HOPE CREEK GENERATING STATION
DOCKET NO. 50-354
NRC REVIEW OF STRUCTURAL/GEOTECHNICAL TOPICS

Attachment: Resolution of NRC Comments on
Structural/Geotechnical Topics

Response to NRC Audit

SHEAR RESPONSE MAXIMA FOR DRYWELL

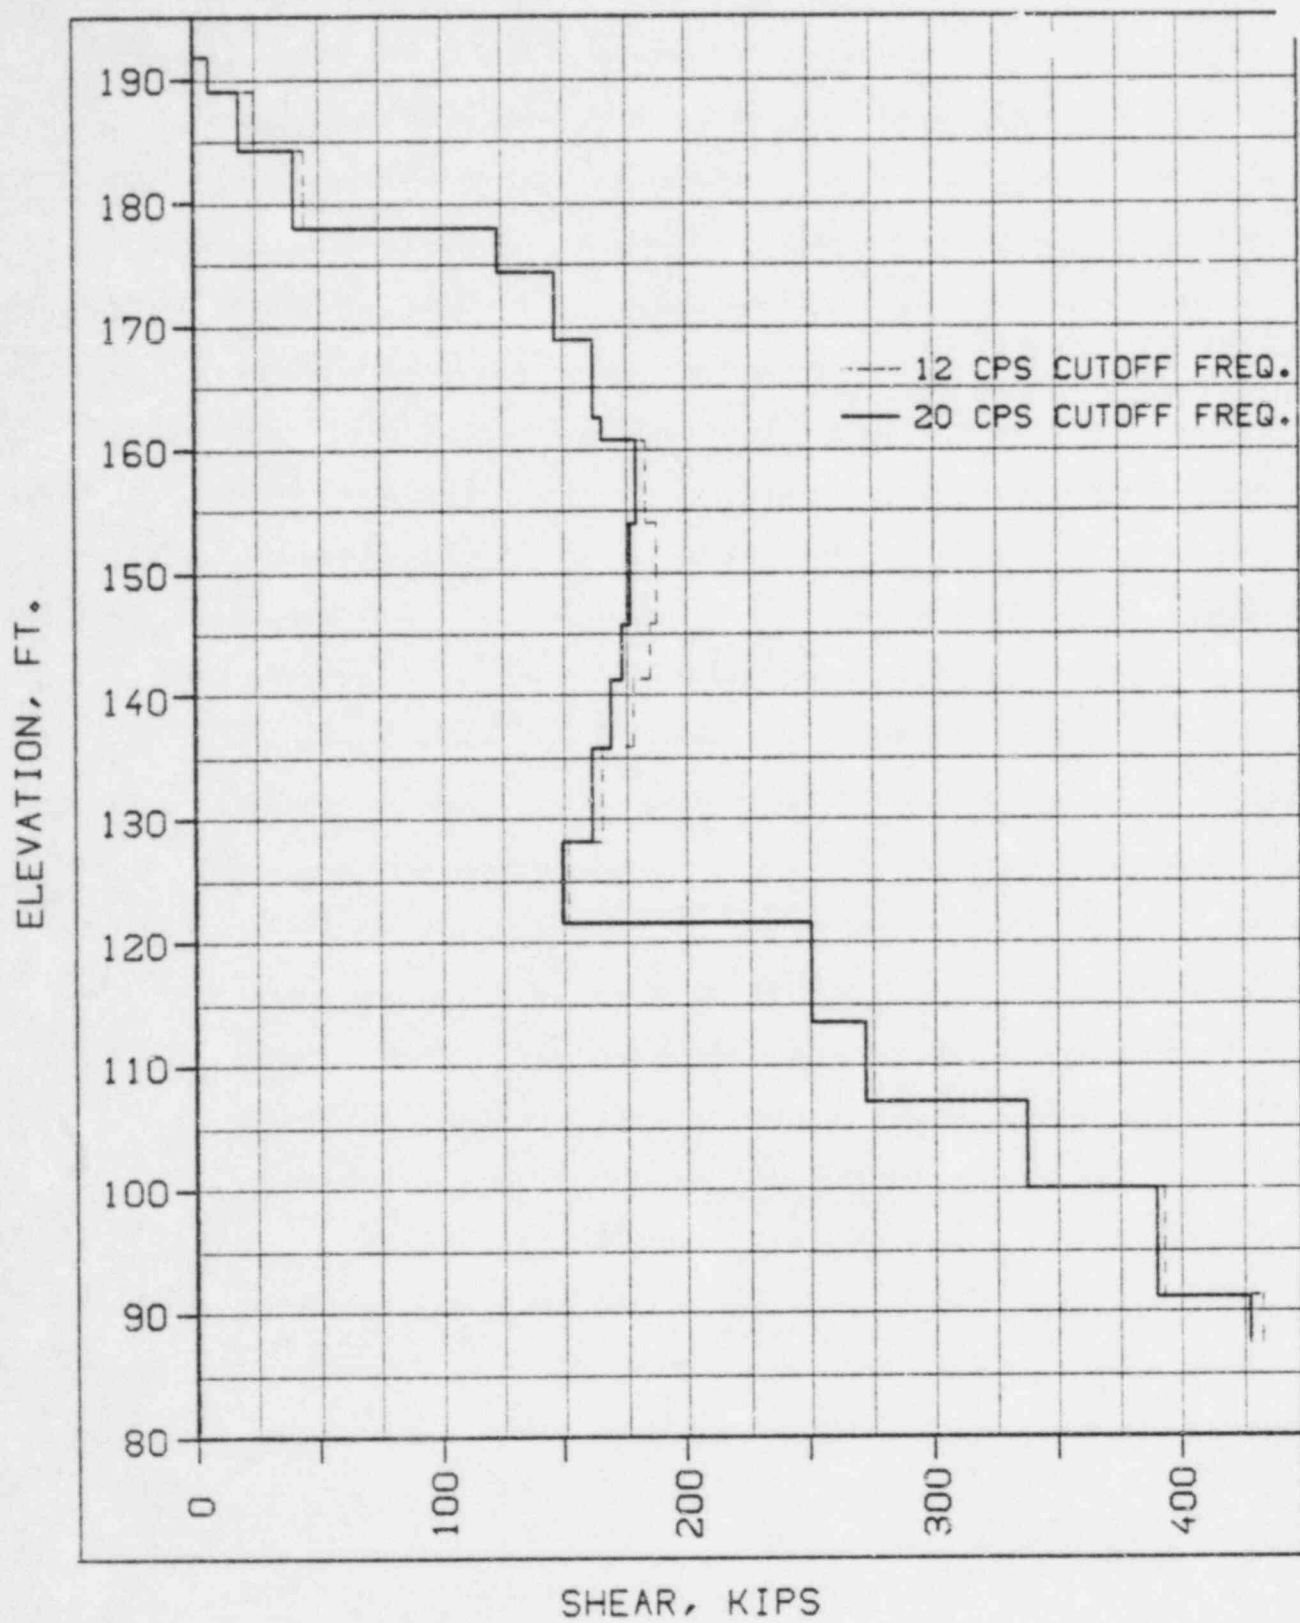
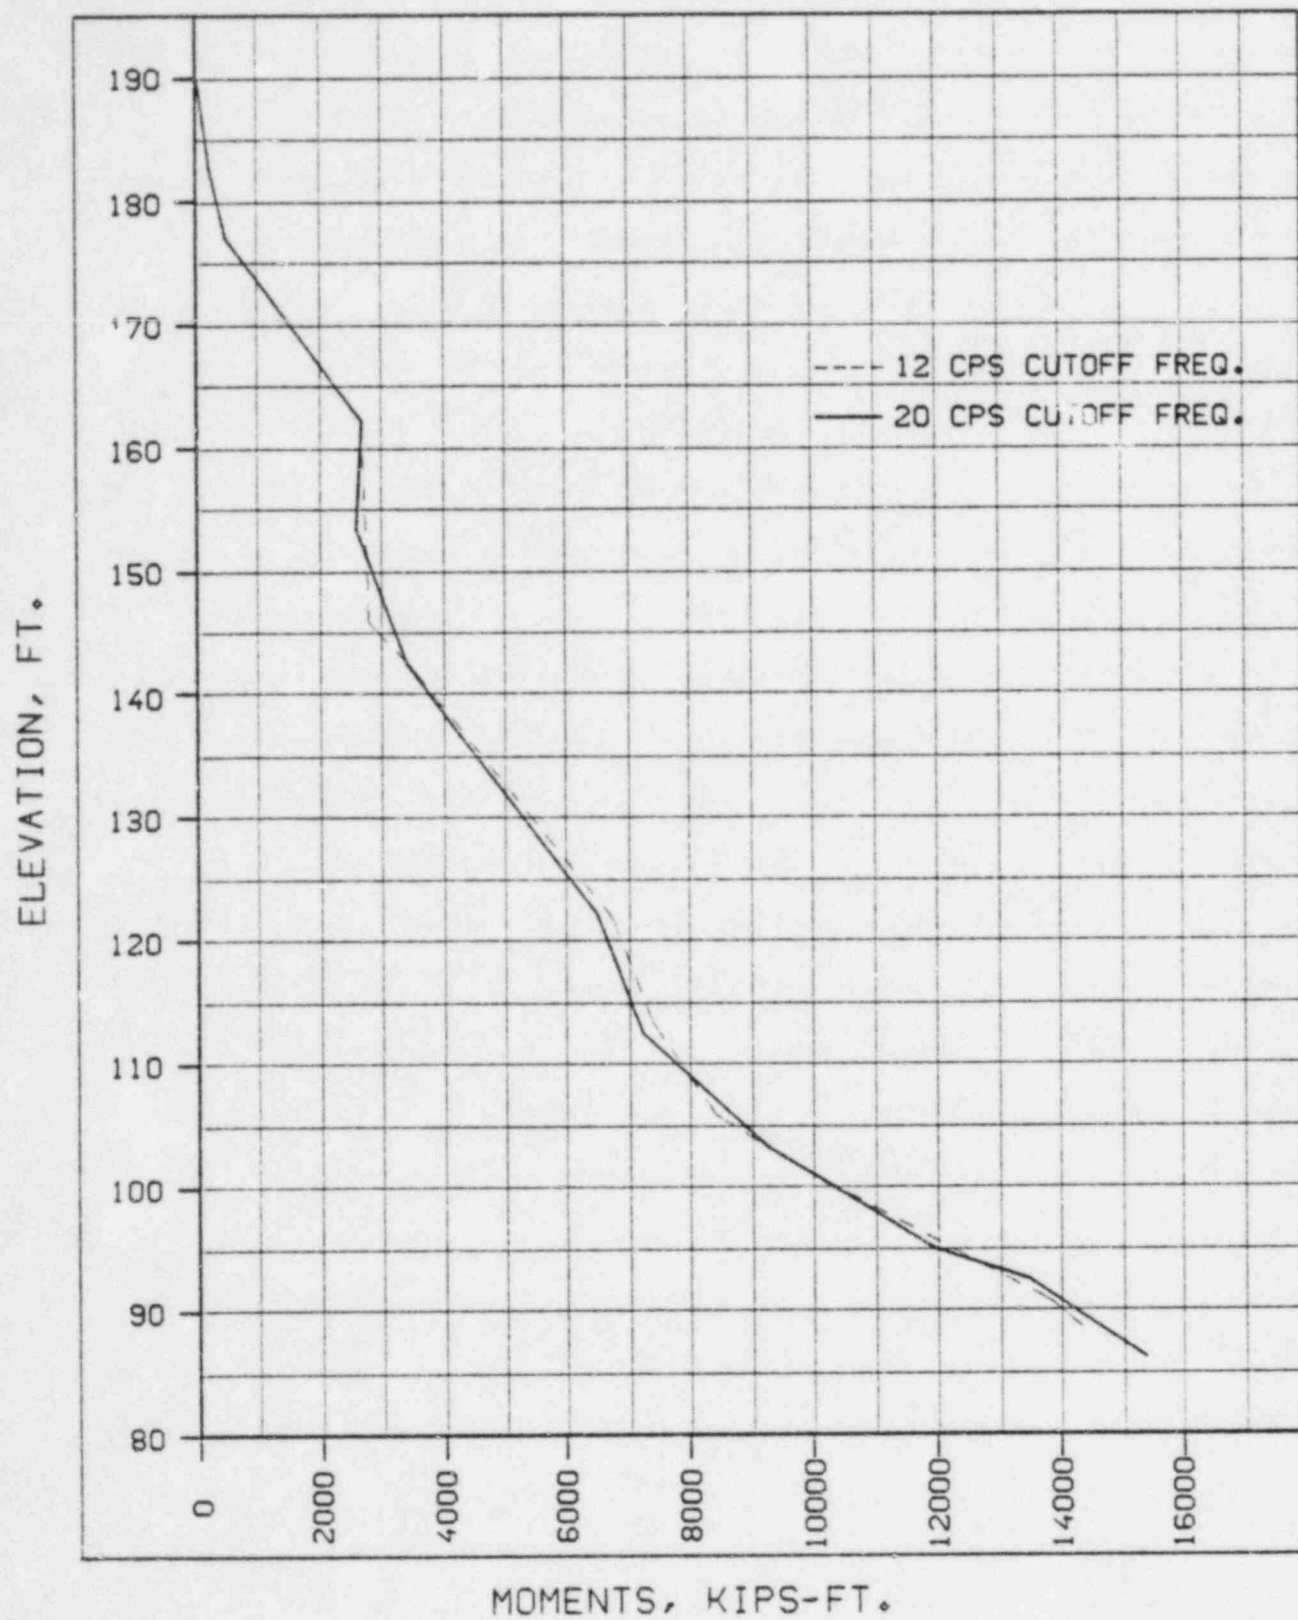
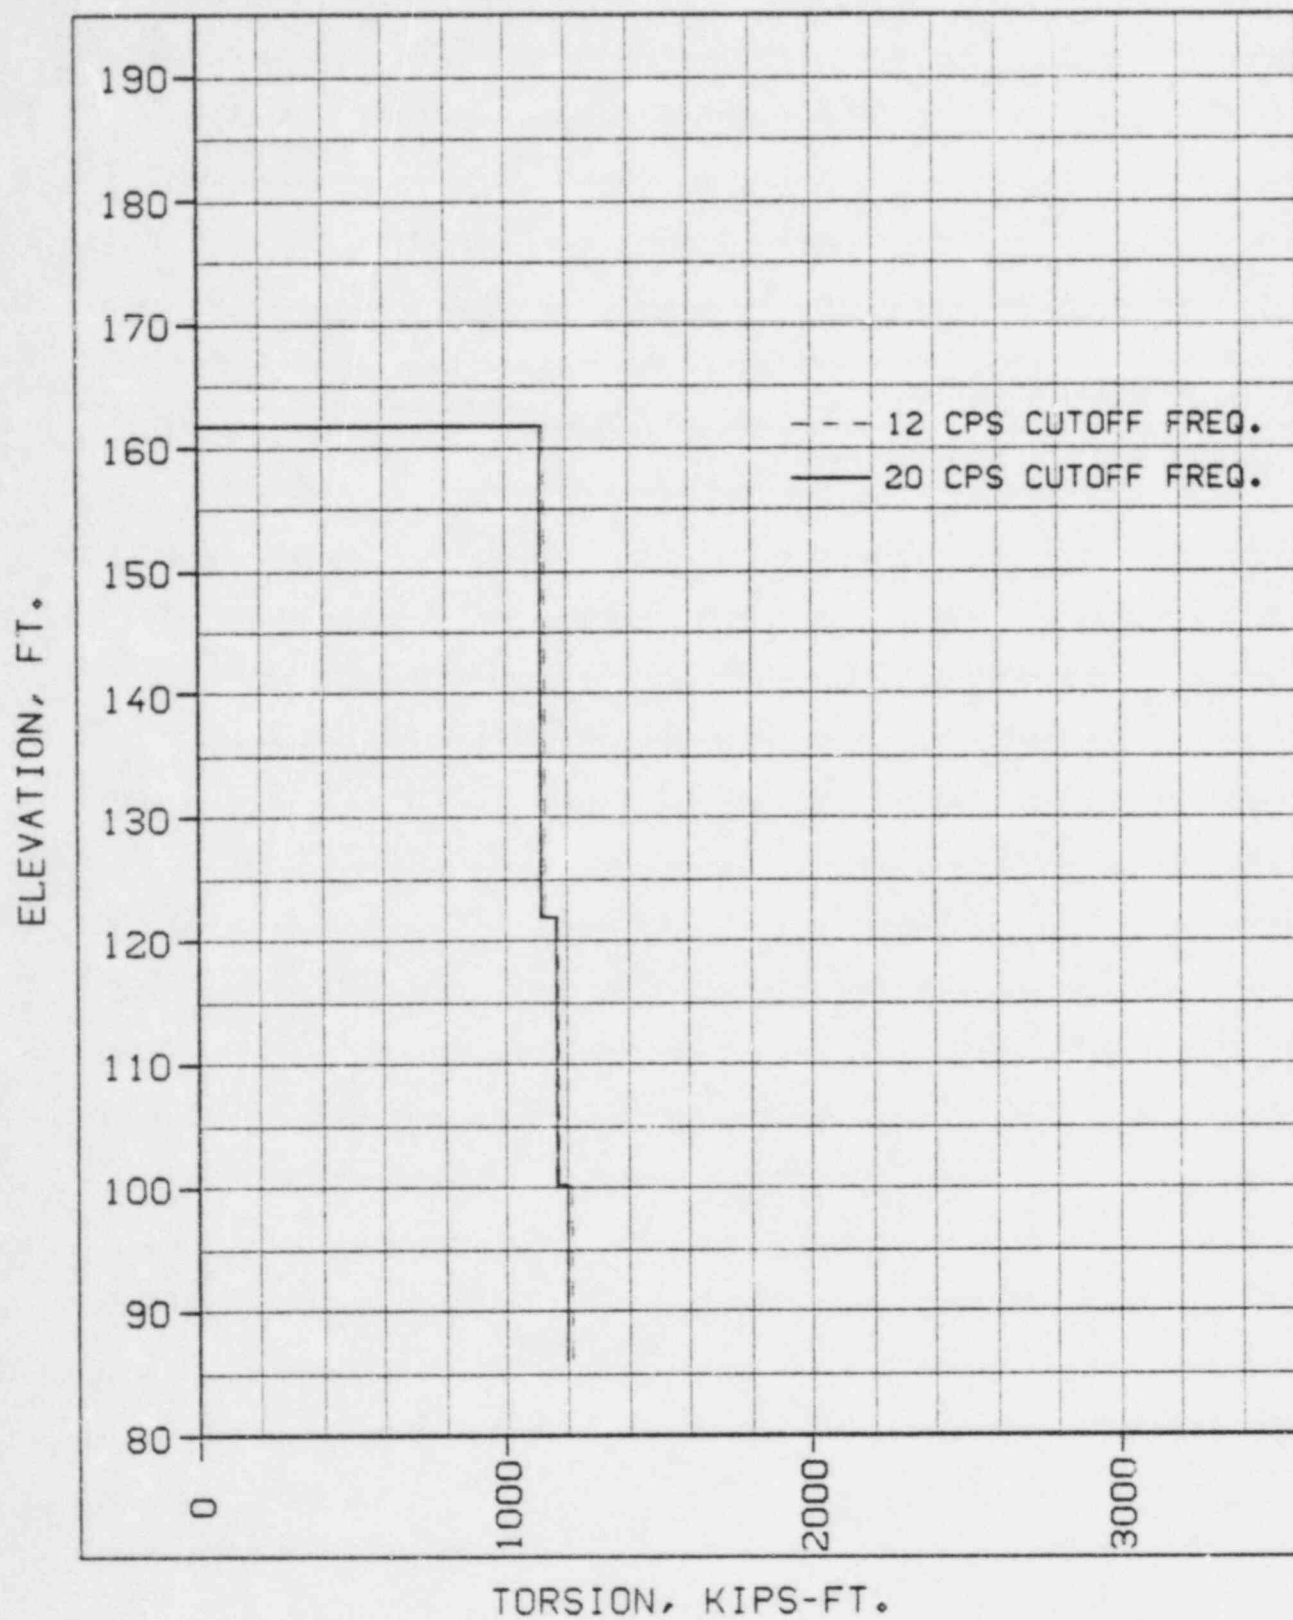
QUESTION: Justify the 12 Hz. cut-off frequency for SSI analysis.

Figures 6 through 8 present response maxima for shear, moment and torque in the drywell of the Reactor Building, when subjected to each of the base mat excitations. The drywell was selected for comparison of cut-off frequency effects because it is a portion of the reactor pressure boundary, and the design of this structure is particularly critical. The comparison of results for the drywell is representative of other portions of the structure as well. As can be seen from these plots, the response maxima of the structure are virtually independent of the high frequency acceleration components of the base mat motion. Clearly the shear, moment and torque response values for the structure are essentially identical for the two different cut-off frequencies, indicating a dependence only on the low and mid frequency range of the base mat motions.
